Hurricane Planning Commission Meeting Agenda

February 12, 2026
6:00 PM

Agenda Date:	02/12/2026 - Planning Commission
Application Number:	GPA26-01
Action Type:	Legislative
Applicant:	Adam Nielson
Agent:	Karl Rasmussen
Request:	Request for a General Plan Amendment from Single Family to Multifamily.
Location:	1015 N 200 W
Zoning:	R1-10
General Plan Map:	Single Family
Recommendation:	Deny
Report Prepared by:	Fred Resch III

Agenda Date:	02/12/2026
Application Number:	ZC26-01
Type of Application:	Zone Change Application
Action Type:	Legislative
Applicant:	Adam Nielson
Agent:	Karl Rasmussen
Request:	A Zone Change from R1-10 to RM-1
Location:	1015 N 200 W
Zoning:	R1-10
General Plan Map:	Single Family
Recommendation:	Deny
Report prepared by:	Fred Resch III

DATE	1/14/2026
SCALE	1"=20'
JOB NO.	827-001
SHEET NO.	C1

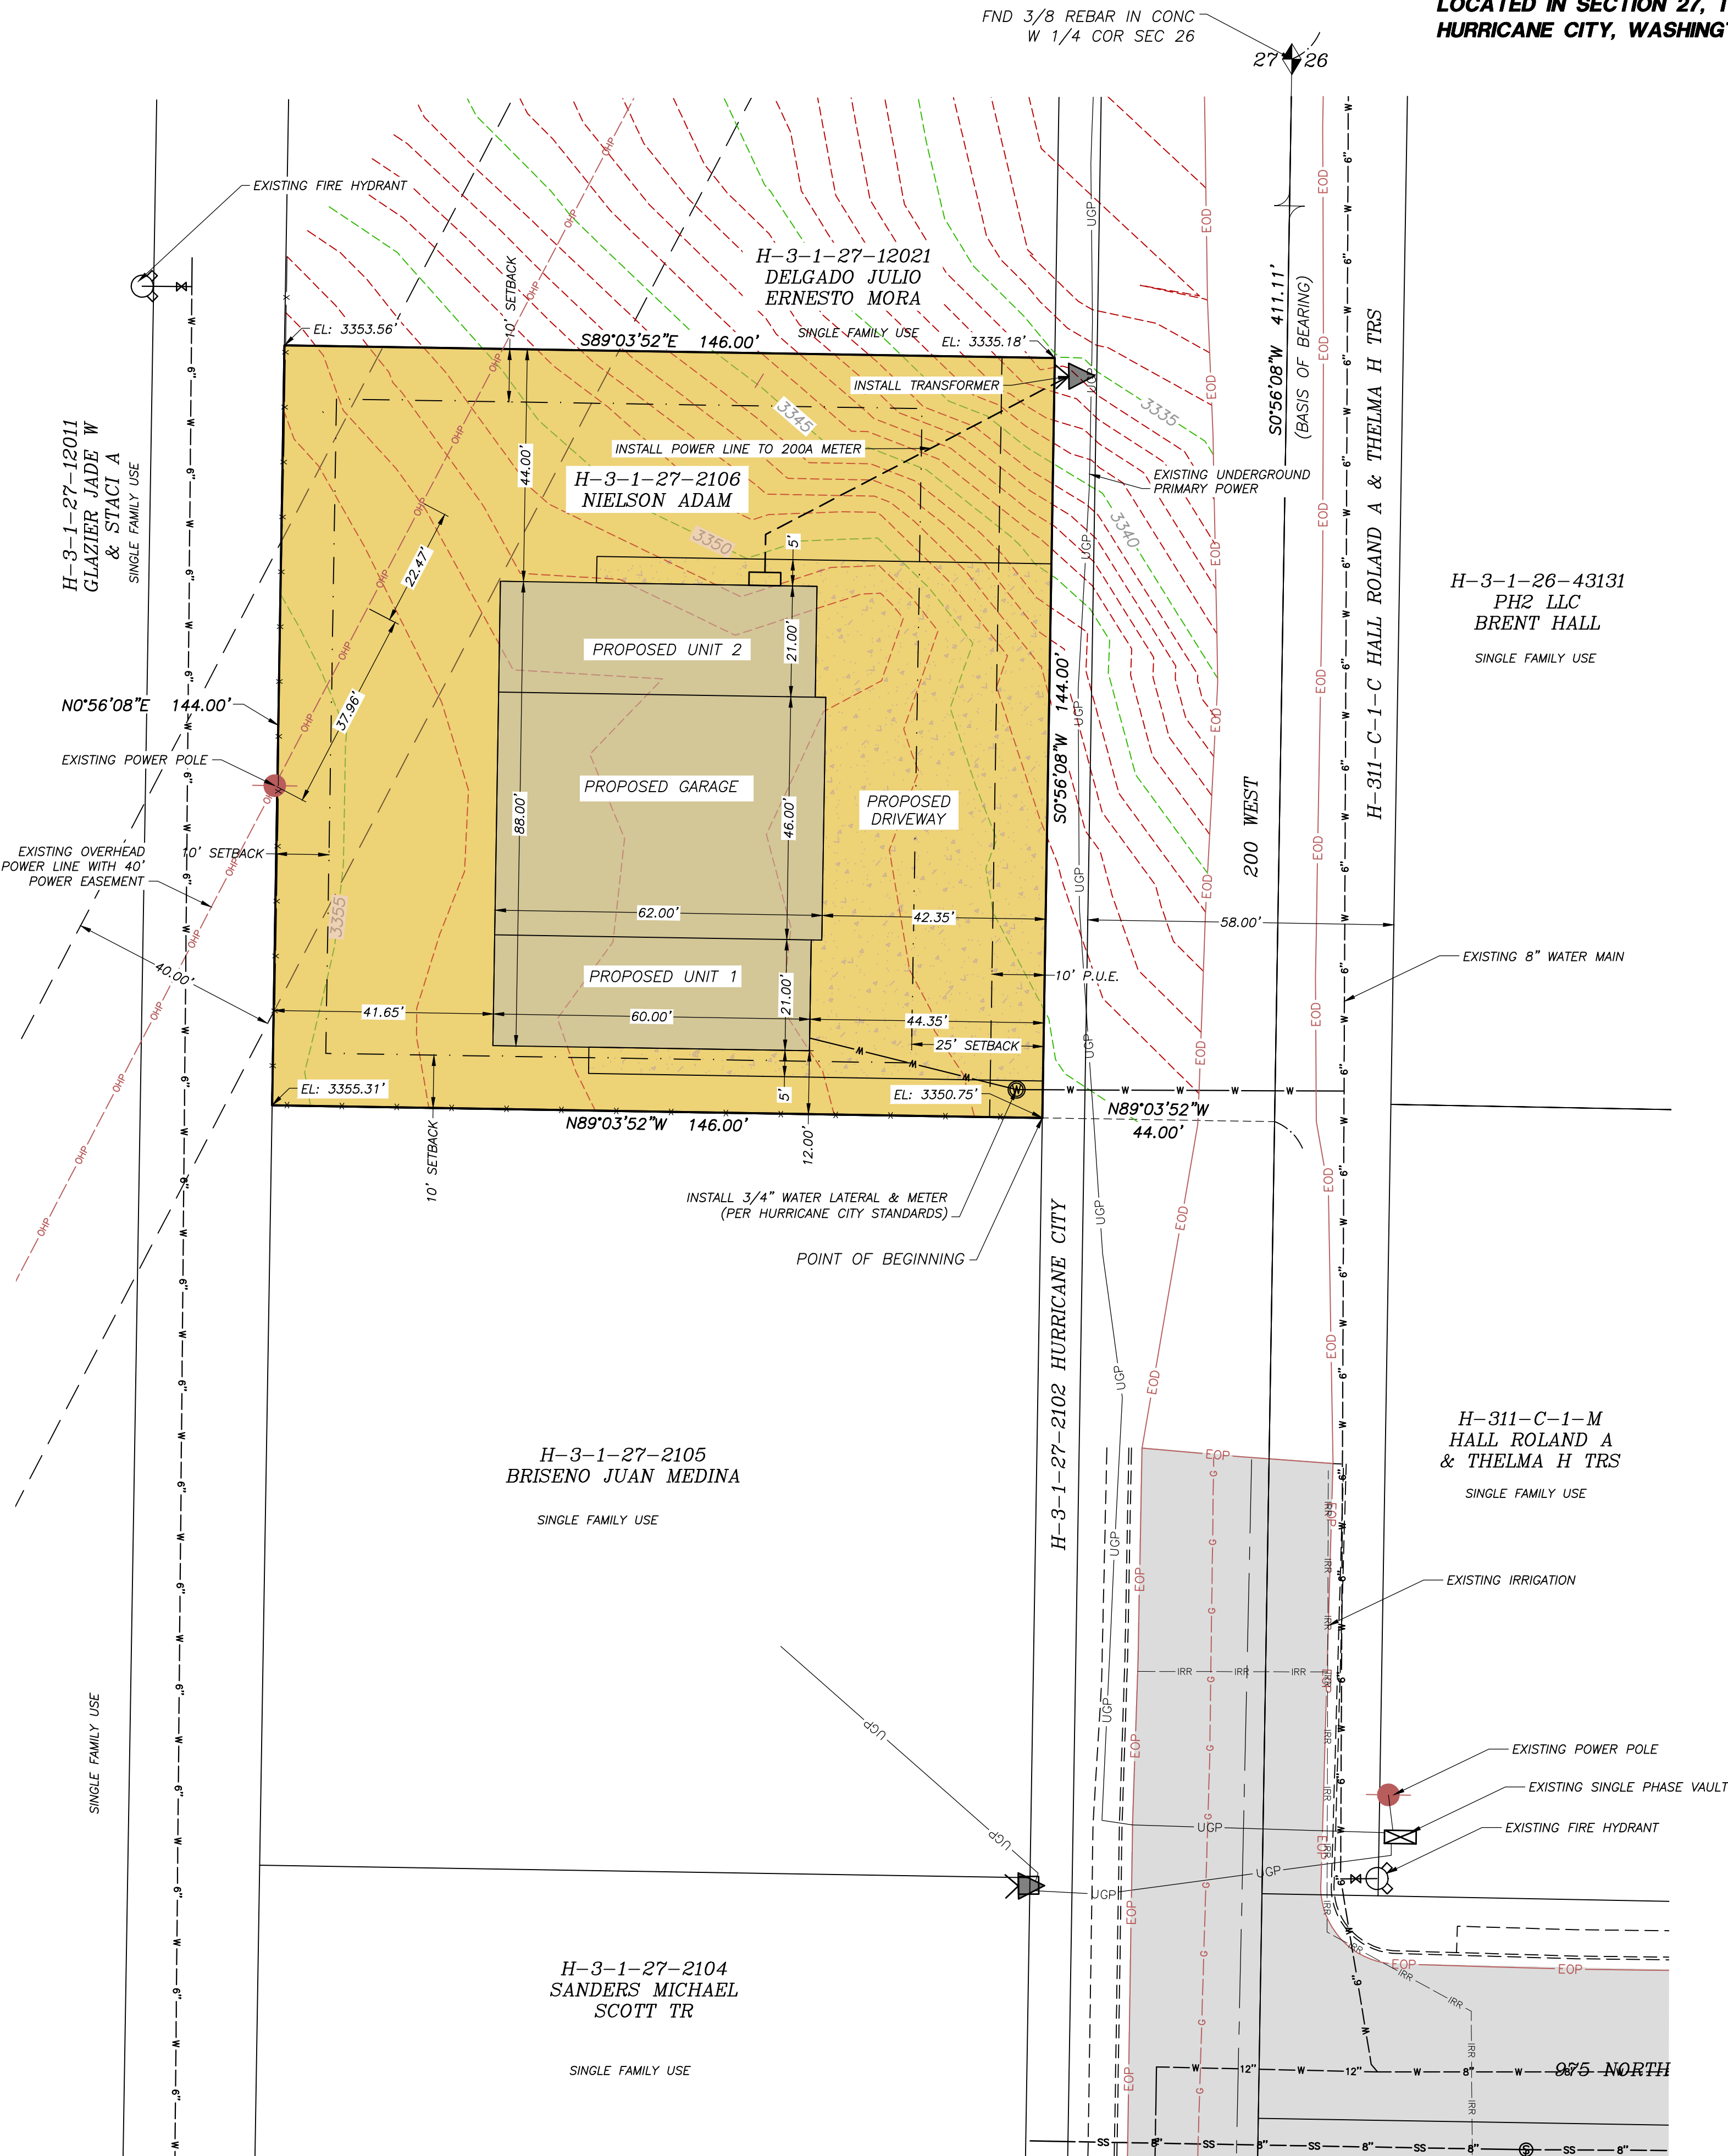
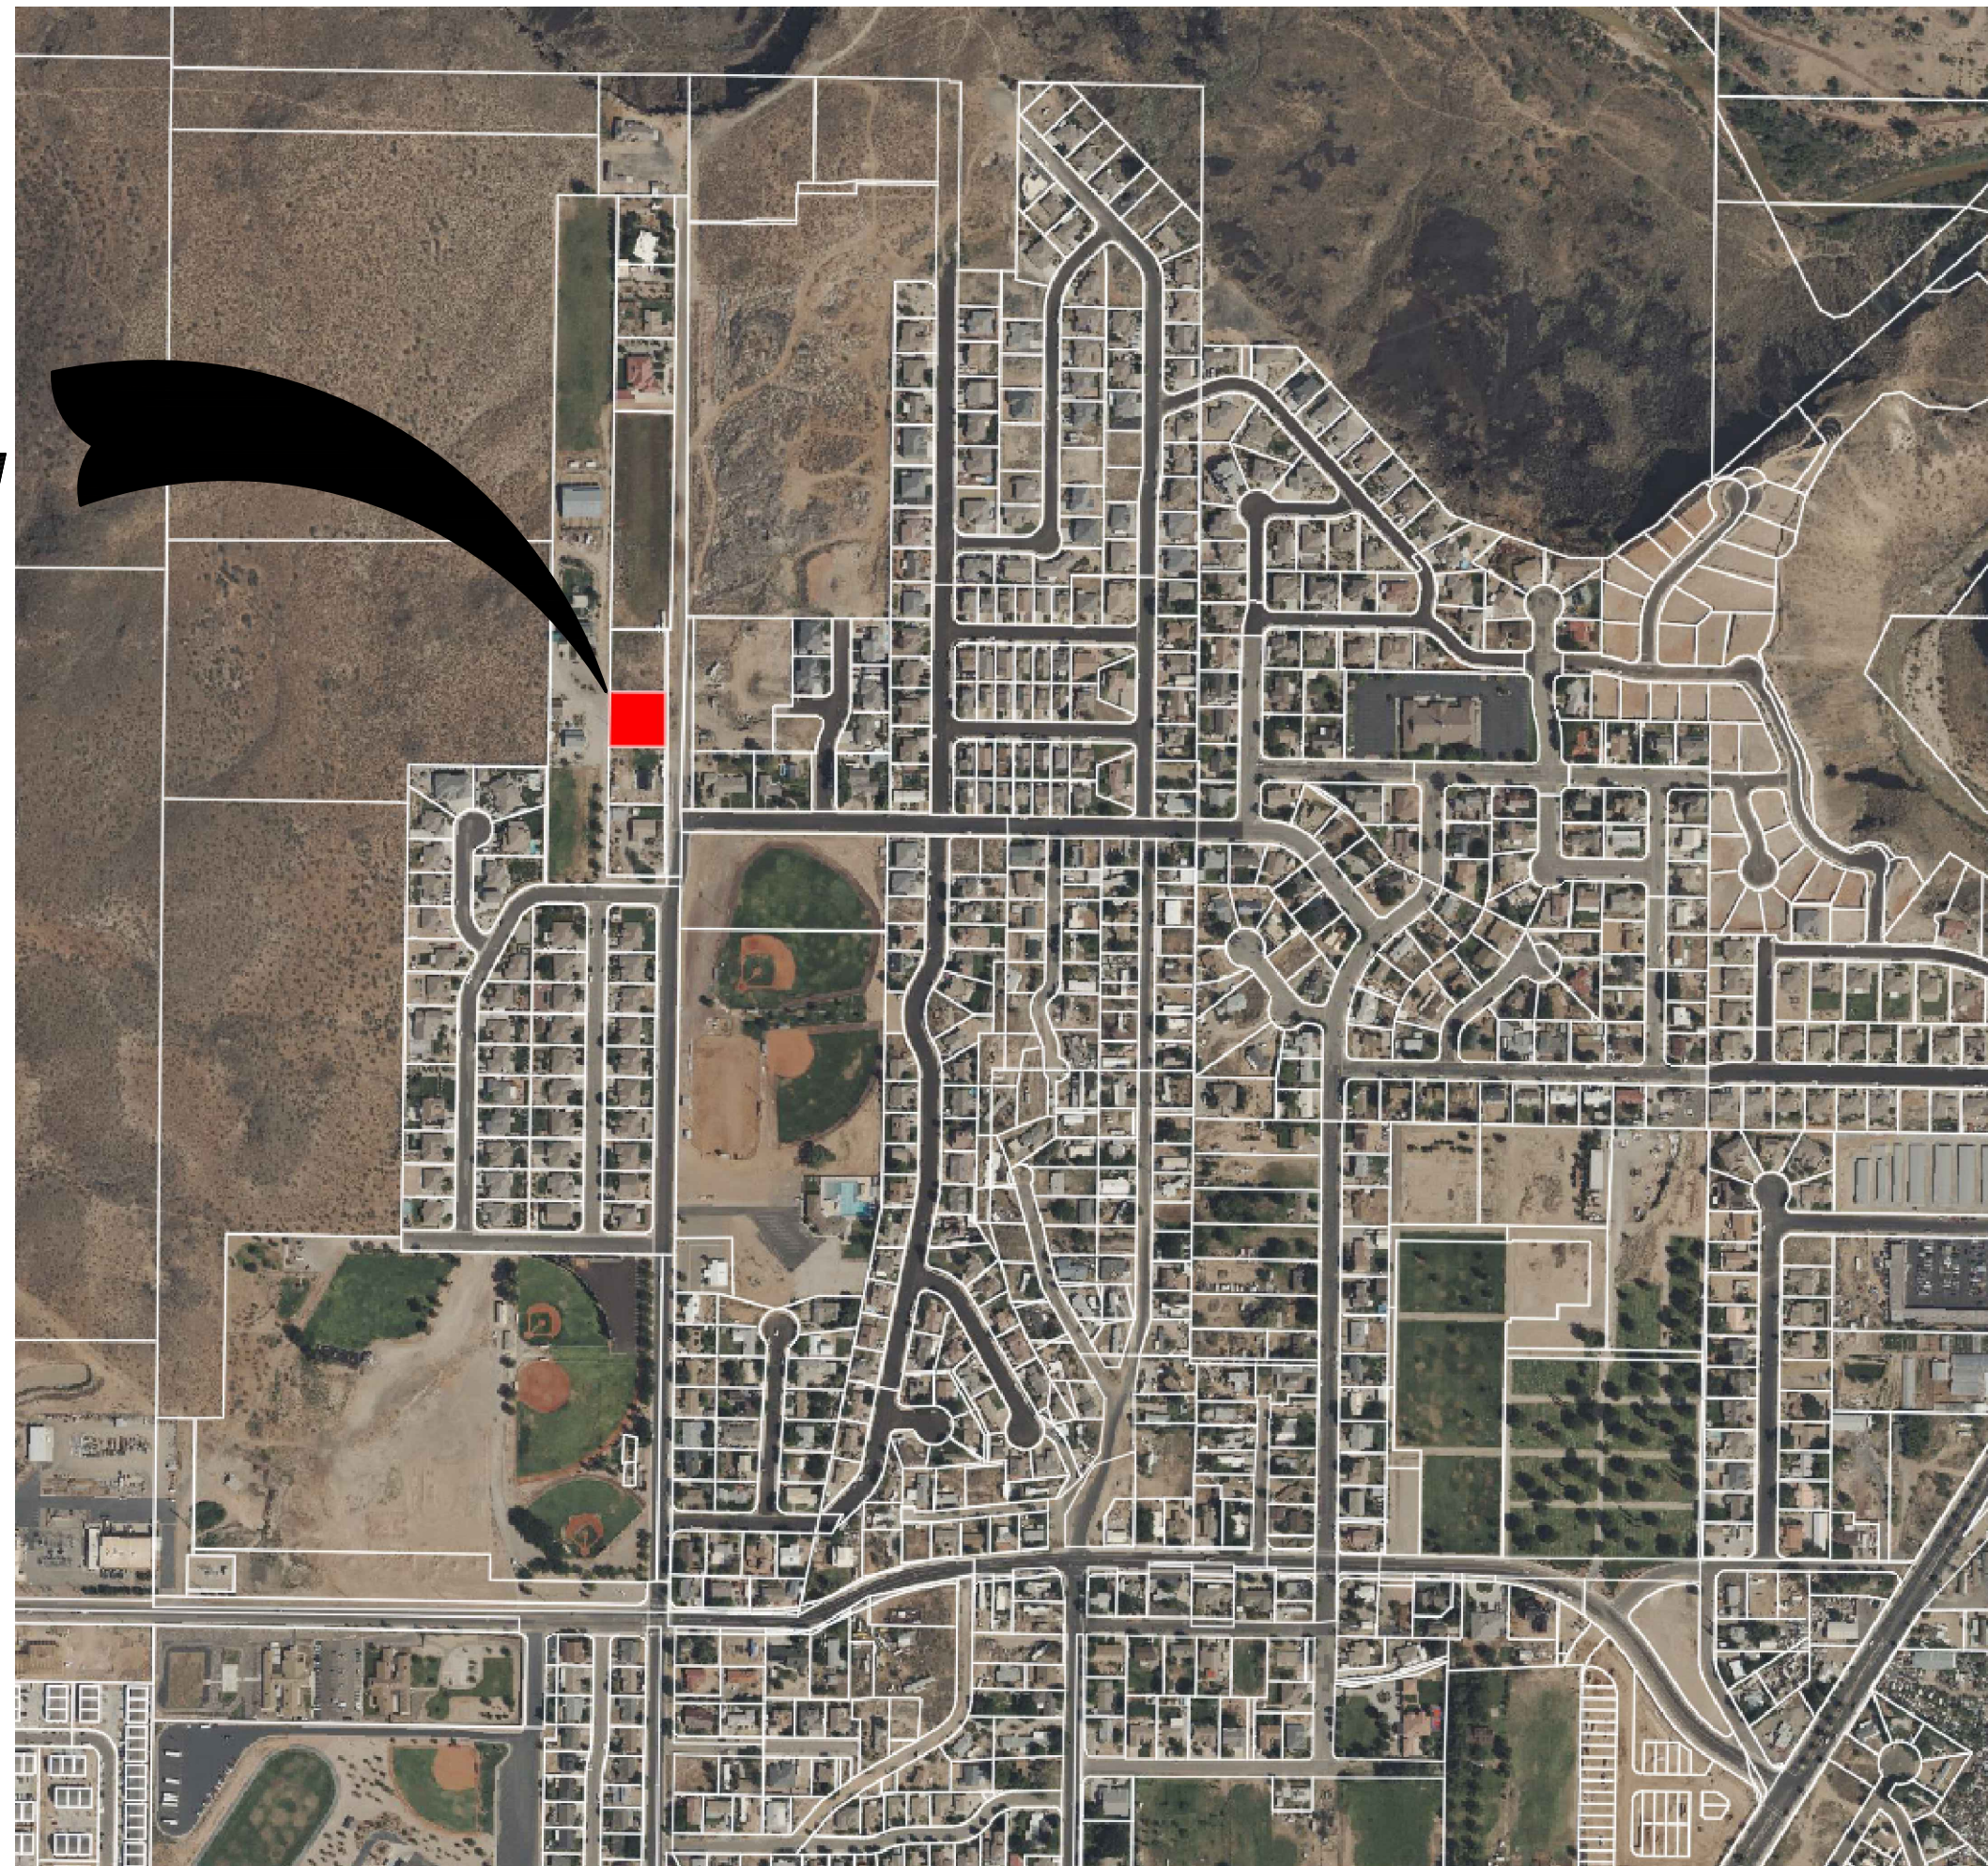
The applicant requests a General Plan Map Amendment on a vacant 0.48 acre lot along an unimproved section of 200 W from Single Family Residential to Multifamily. The applicant has also applied for a zone change which will be treated as a separate item. All changes to the General Plan Map should be supported by the General Plan and by best planning practices and principles.

Planning Principles: The General Plan serves as a flexible, advisory framework for managing citywide growth, where land-use boundaries are intentionally fluid rather than rigid. However, this inherent flexibility necessitates caution: amending a designation for a single parcel may establish an undesirable precedent for the surrounding area. While the City maintains broad legislative deference in zoning matters, a General Plan Amendment for this property could serve as a catalyst for higher-density zoning and development within the broader neighborhood.

1. The request does not meet all the goals and policies of the General Plan Map.
2. This request does not match proper planning principles, and a “spot designation” on the General Plan Map would be inappropriate.

Recommendation: Staff recommends that the Planning Commission consider any public comments received in the public hearing and send a recommendation of denial to the City Council due to not aligning with the intent of the General Plan or proper planning principles.
